Licence Number	L8621/2011/1
Licensee	Roy Hill Iron Ore Pty Ltd
ACN	123 722 038
Registered business address	5 Whitham Road PERTH AIRPORT WA 6105
Date of amendment	16 November 2017
Prescribed Premises	Category 5 – Processing or beneficiation of metallic or non-metallic ore Category 6 – Mine dewatering Category 12 – Screening, etc. of material Category 54 – Sewage Facility Category 57 – Used tyre storage (general) Category 64 – Class II putrescible landfill site Category 73 – Bulk storage of chemicals, etc.
Premises	Roy Hill Iron Ore Mine M46/518 and M46/519 NEWMAN WA 6753

Amendment

Amendment Notice

This Notice is limited to an amendment for an increase in the height of the Stage 2 raise of the tailings storage facility (TSF), requirement to monitor groundwater monitoring bores located near the TSF and removal of condition 1.2.1 following decommissioning of the Samsung C&T Wastewater Treatment Plant (WWTP).

8. Schedule 1: Maps, Map of licence exclusion. This map has been deleted from the licence.

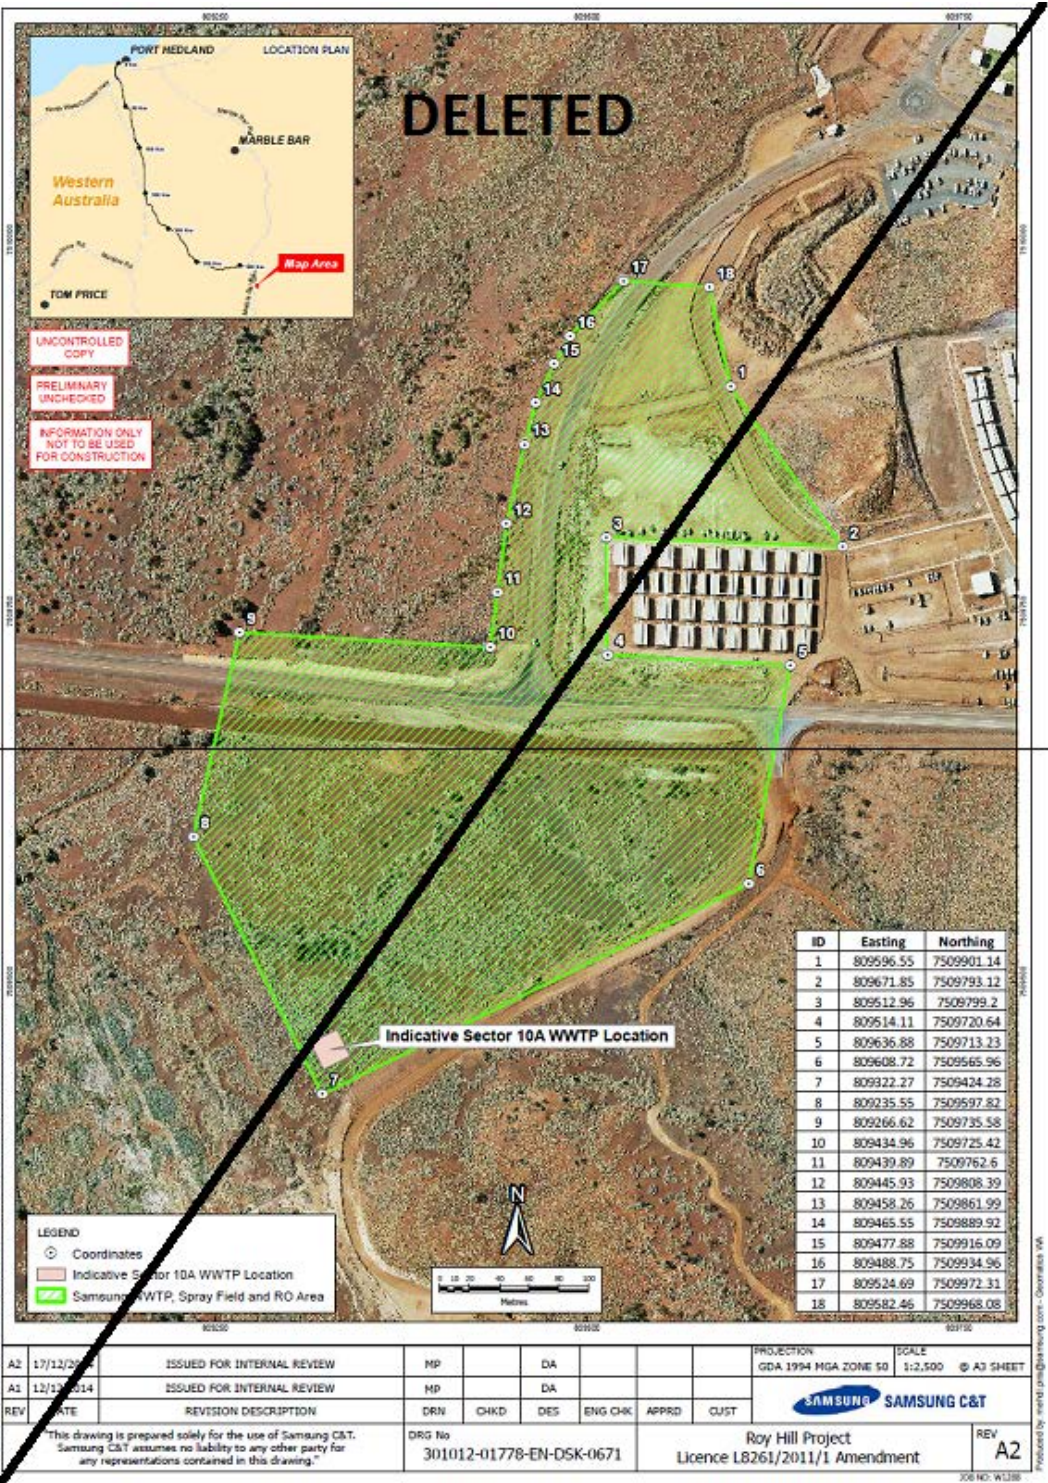
The Delegated Officer considers the request for removal of Condition 1.2.1 and Schedule 1, 'Map of licence exclusion', appropriate. The removal of these is demonstrated in the following amendment information.
